**Our Case Number: ABP-316272-23**

**Re:** Bus Connects Templeogue/Rathfarnham to City Centre Core Bus Corridor Scheme  
Templeogue/Rathfarnham to City Centre

This submission is being made by  
David O'Doherty and Niamh Tierney of  
68 Terenure Road East  
Terenure  
Dublin 6

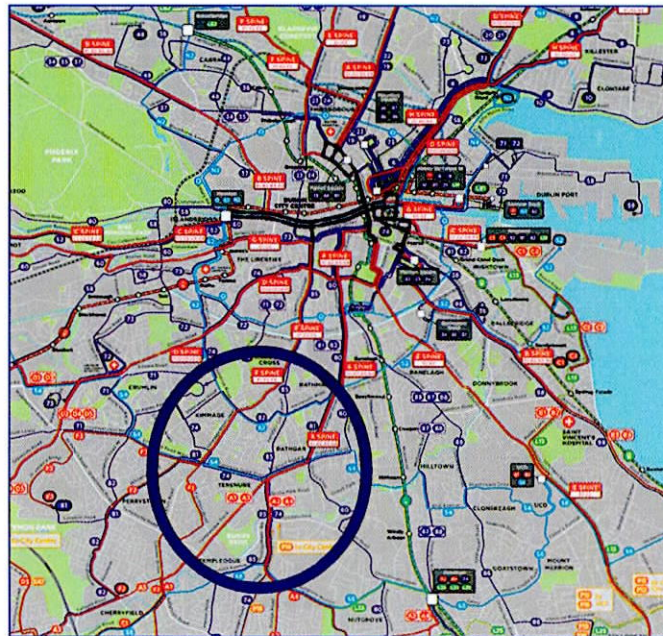
**“... Bus infrastructure on this key access corridor in the Dublin region, which will enable and deliver efficient, safe, and integrated sustainable transport movement along the corridor”**

A key issue with this statement of the NTA objective is that while it may well deliver bus infrastructure along the corridor, the reality of which is disputable, and perhaps it delivers integrated sustainable transport movement along the corridor, it does so at a significant cost to all other transport movement in the peripheral road network surrounding the corridor.

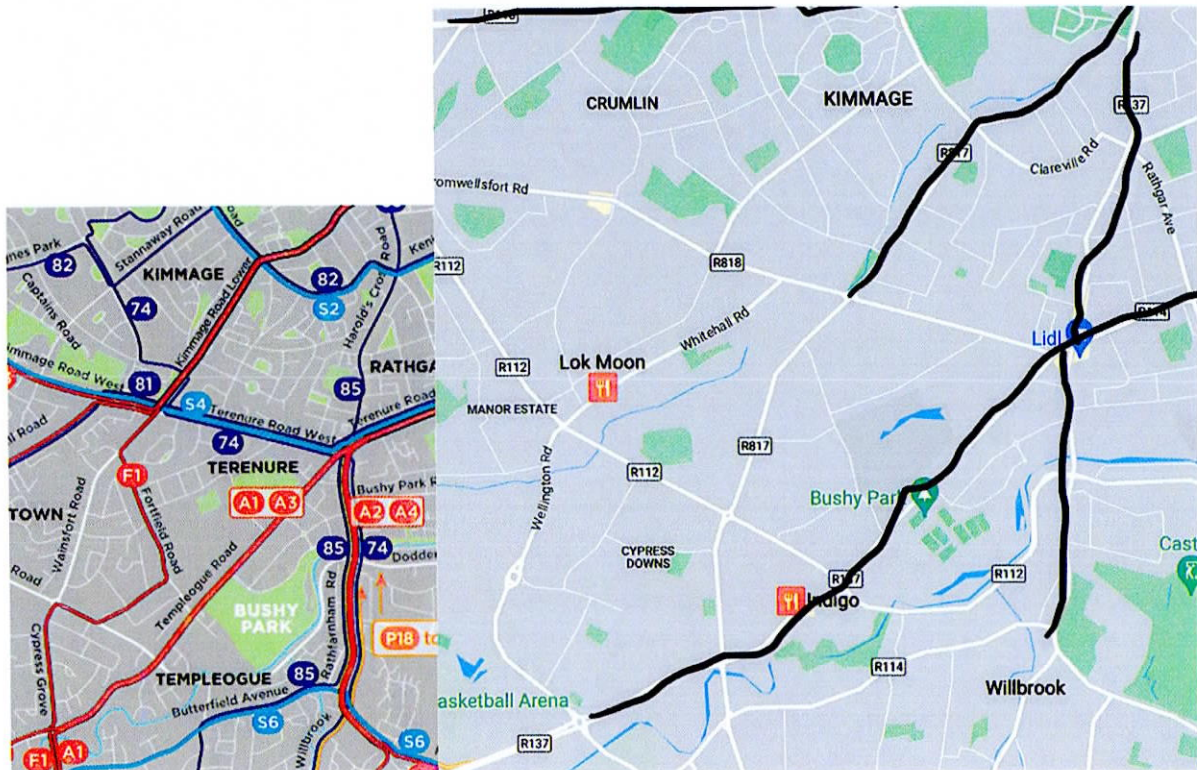
The map below with the black lines is drawn to demonstrate that a very small area is affected by the bus corridors, drawn in black lines, with the attendant bus gates. What is not drawn is the other changes and the increasing traffic in the peripheral roads. There is a heavy concentration of bus corridors influencing a small area outside of the city centre, this is unusual across the entirety of the network and creates a disproportionate burden on the communities living there.

The map with the F1 bus route shown below on Cypress Grove Road and Fortfield Road, shows the only viable alternative for access to the city centre, hospitals, etc for that area and it will be accompanied by all of the traffic that is diverted from the Bus Corridor under consideration and it will be limited by the Kimmage Bus Corridor, where the red line for the F1 thickens. As the surrounding roads are either not accessible at all because of a bus gate, or barred from access due to the implementation of a ban on right hand turns, this route will be overpopulated with traffic, and yet this is a significantly increased bus route. This might be bearable if it were during rush hour/peak traffic times only, but it isn't – it's from 6am to 8pm every day of the week. The timing of the bus gate is nonsensical and an unnecessary diminution of the quality of life of the residents in that area. Residents will have to drive much longer routes to gain access and egress from their roads and to access hospitals, doctors, dentists, schools and shopping areas.

Meanwhile the 54A bus route as it was, proposed now as the F1, will be removed from its route along Templeville Road, a cause of much distress to elderly residents on Grosvenor Court off Templeville Road, who until now have ease of access to this bus route but under new plans will have to walk a considerable distance. This bus route will no longer travel the road outside Templeogue College, removing that direct connectivity up to a road running perpendicular to Templeville Road. Its route
